Village of Arlington Heights
Plan Commission
Board Room
Arlington Heights Village Hall
33 S. Arlington Heights Road
Arlington Heights, IL 60005
July 25, 2018
7:30 PM

- A. Napleton/Arlington Lanes Parking Lot - 3435 N. Kennicott Ave. -
PC#18-014
Land Use Variation for Auto Sales Lot, Variations
- B. Arlington Downs - 3400 W. Euclid Ave. - PC#18-010
PUD Amendment, Plat of Subdivision, Amendment to SUP,
Land Use Variation, Variations

REPORT OF THE PROCEEDINGS OF A PUBLIC HEARING
 BEFORE THE VILLAGE OF ARLINGTON HEIGHTS
 PLAN COMMISSION

RE: EUROPEAN CRYSTAL HOTEL - 519 WEST ALGONQUIN ROAD - PC#18-013
 LAND USE VARIATION FOR HOTEL, VARIATION FROM CHAPTER 28 OF THE
 MUNICIPAL CODE

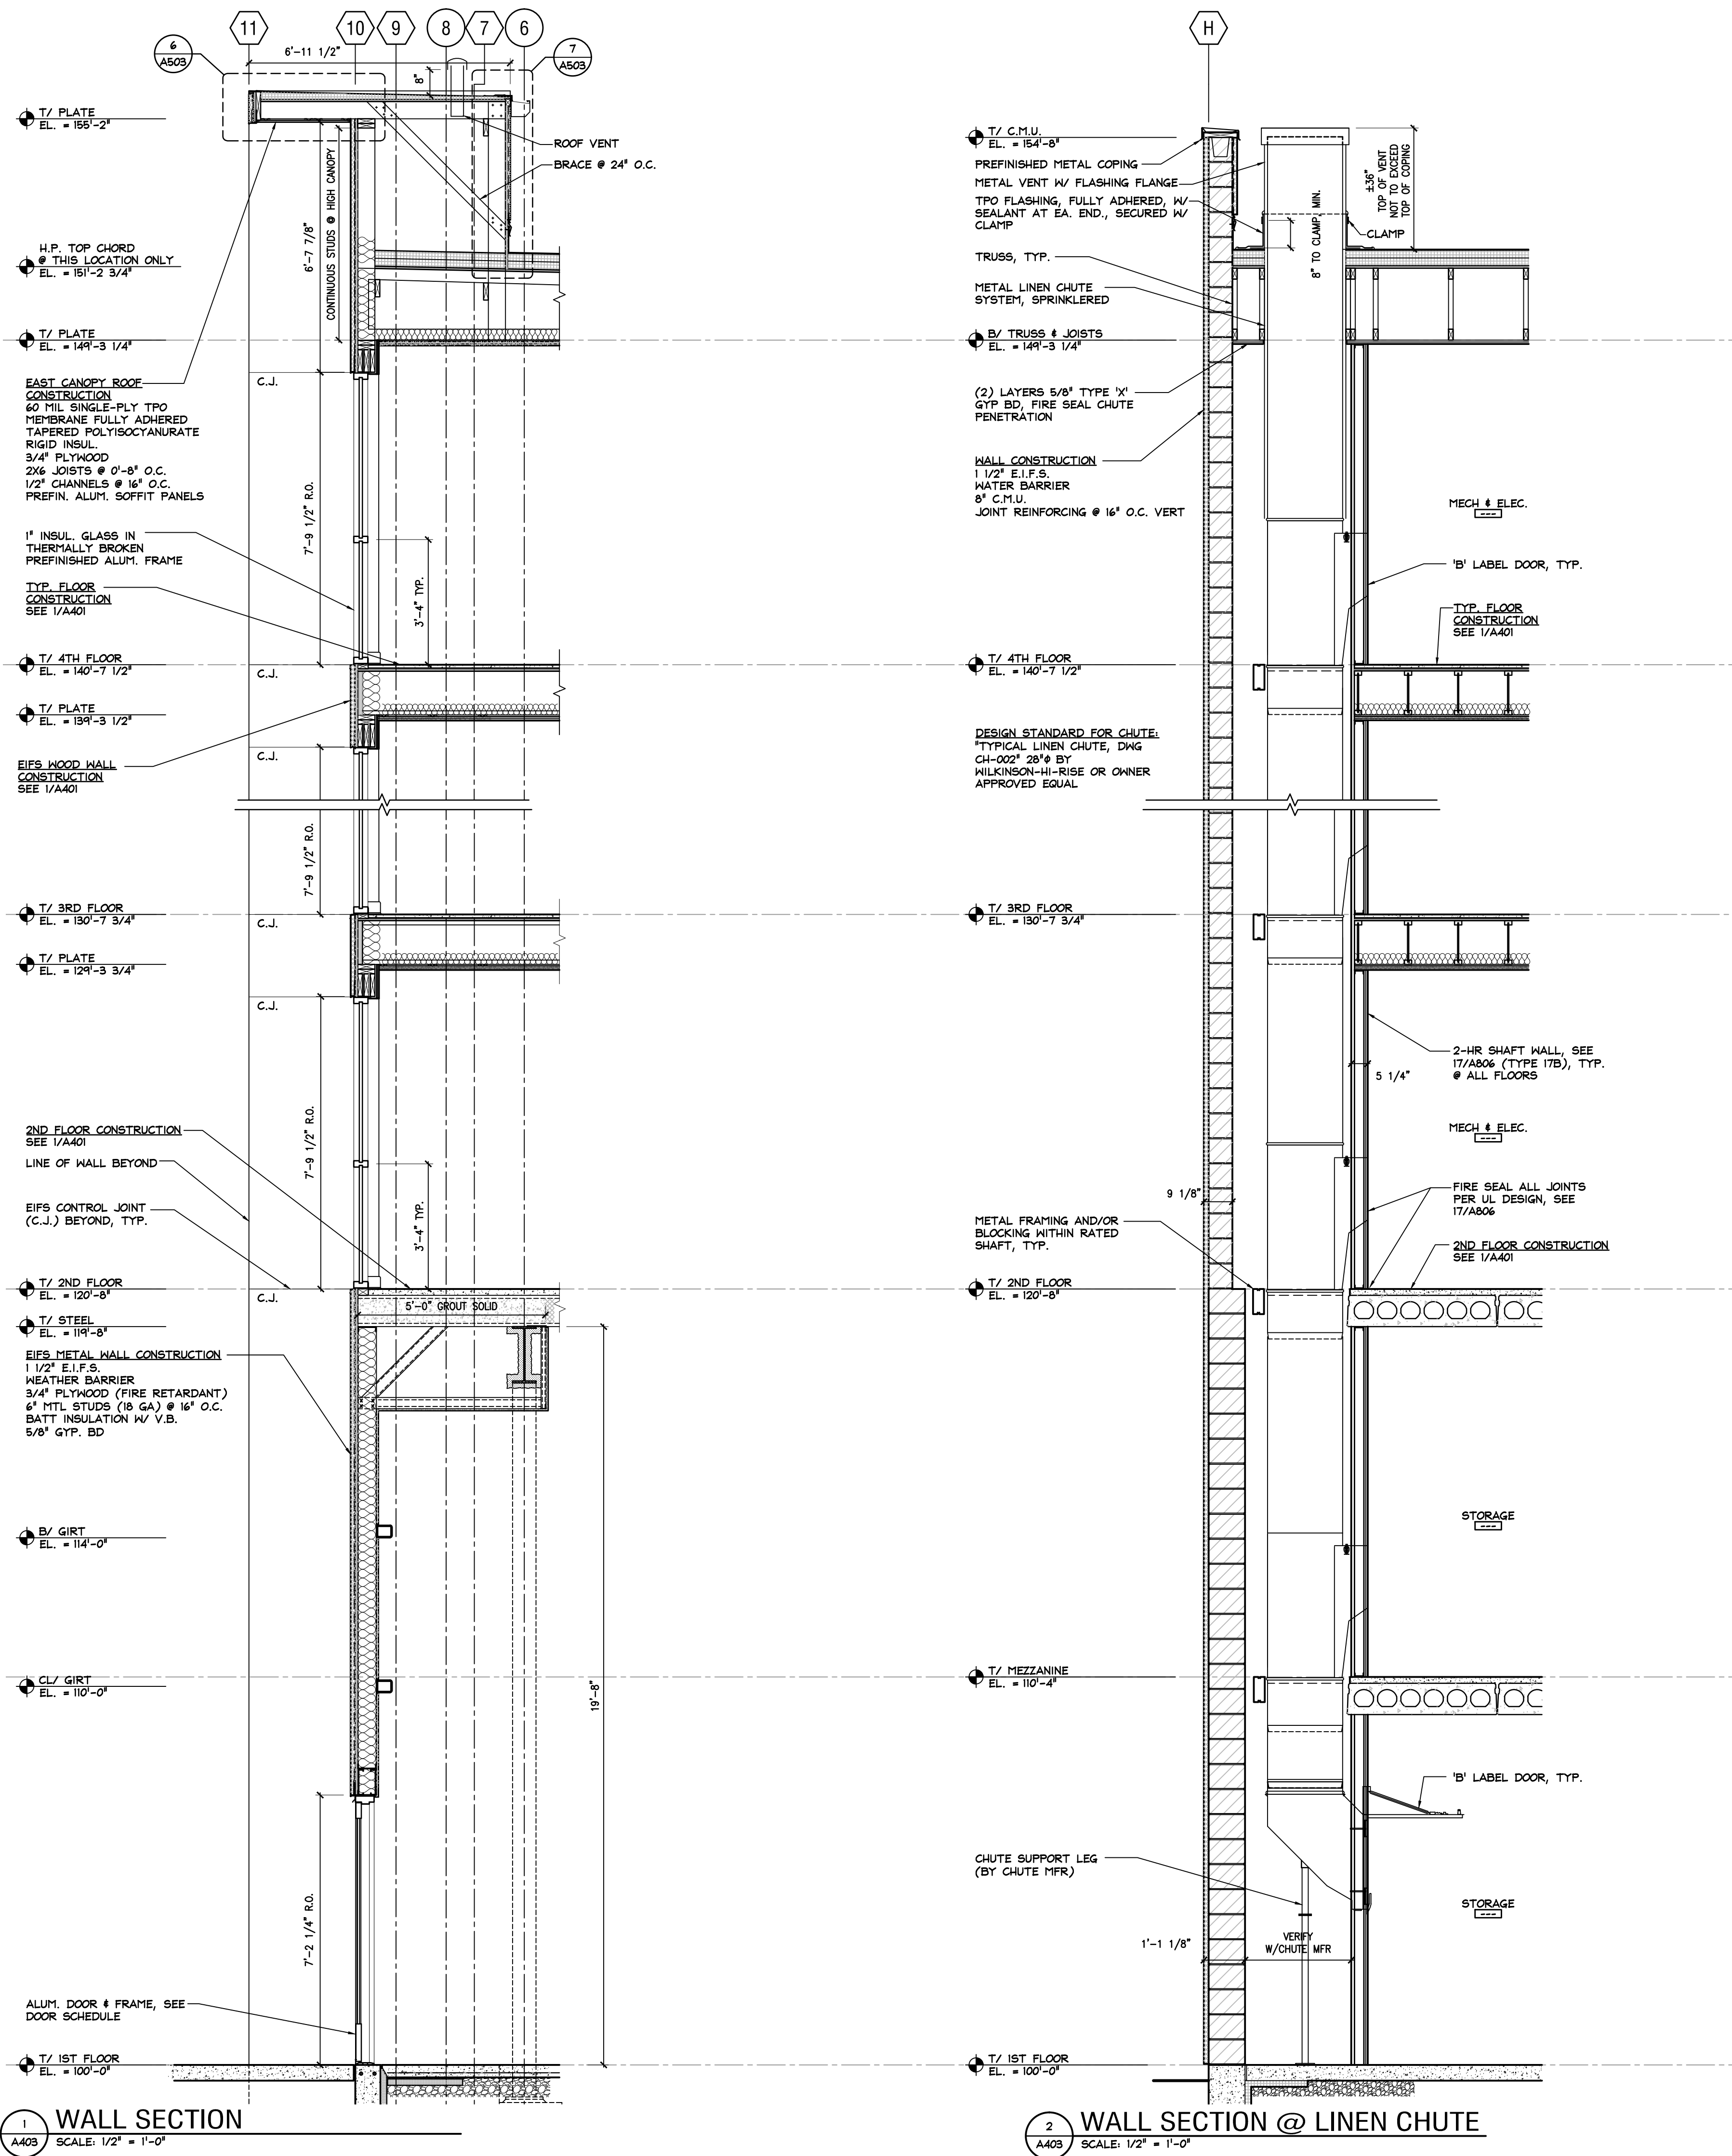
22. Sheet A010 needs revisions. Please clarify/revise the following:

36. Please provide a parking chart on sheet A010 that outlines the total number of parking spaces provided in each zone (excluding zones C, Lot 2B, and Lot 16). Please differentiate between surface parking and garage parking.

22. Sheet A010 needs revisions. Please clarify/revise the following:
- Does the overall square footage calculation include Lot 16? The lot acreage only seems to take into consideration the area of Lot 2B, but it does not seem to take into account the area in Lot 16. Please add this to the Lot Coverage table.

- Please add a column to the Lot Coverage Table that outlines the impervious surface coverage in each zone except Zone C, Lot 2B, and Lot 16.
 - Please incorporate the following density table to sheet A010

36. Please provide a parking chart on sheet A010 that outlines the total number of parking spaces provided in each zone (excluding zones C, Lot 2B, and Lot 16). Please differentiate between surface parking and garage parking.

- b) Please cross-check all data within the tables on sheet A010. The square footage of retail/restaurant buildings A, B, C, and D as shown on the site plan equates to 30,300 square feet, however, the data within the table shows it as "General Retail, 29,800 sq. ft.", then there is a breakout showing 19,995 square feet for restaurants and the building footprint is listed at 29,900 sq. ft. The data in this table should clearly indicate the overall square footage of the retail/restaurant buildings and the estimated restaurant square footage out of the total.

67. The response to #39 is not acceptable. There are errors in the data provided within the table on Sheet A010. For example, Lot 1A and Lot 2B include 647 total parking spaces, which requires 13 handicap stalls (2% of 647). There are 10 surface handicap stalls, and your data indicates there are 2 in the underground garage, which would bring the total count to 12, but the table indicates there are 16 handicap stalls provided. The plans for ADR-II and the count in the table also don't match. Please double check these numbers to make sure they match what is shown on the plans

- a. The table has been adjusted to read "Zone 2B/Lot 16" and the number of future units listed has been corrected to 360.
- b. Square footages have been re-calculated and the table has been adjusted for increased fidelity.
- c. Civil, architectural, and landscape plans have been coordinated and are consistent across disciplines.
- d. The F.A.R. was previously calculated to include the square footage for the parking garage. This figure has been recalculated and the correct F.A.R. is 1.8, eliminating the need for a variation.
- e. Acknowledged. The Lot Coverage Table on sheet A010 has been updated for precision and accuracy.
